N9913A-02

S E R V I C E N O T E

N9913A FieldFox Handheld Analyzer

Figure 1: Image showing the good and bad inductor on location U678 at RF Board

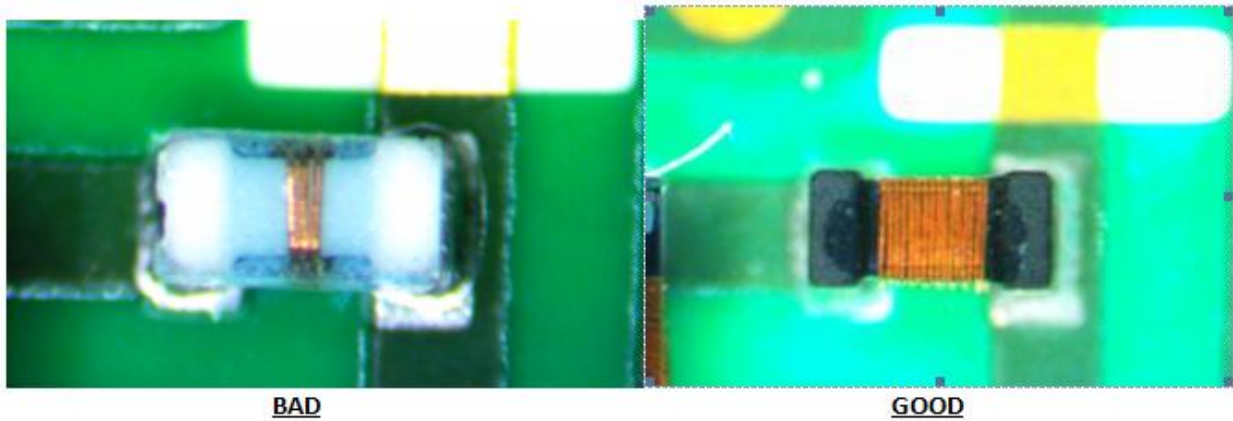
FieldFox instruments with the serial numbers listed below may show potential DANL failures with 3-4 dB difference due to misloaded inductor on the RF board. If DANL improvement is necessary, a new RF board is available to fix this it.

Affected FieldFox with necessary DANL improvement are required to send back to Agilent factory for a new RF board replacement. Test and Adjustment shall be done before shipping back to customer.
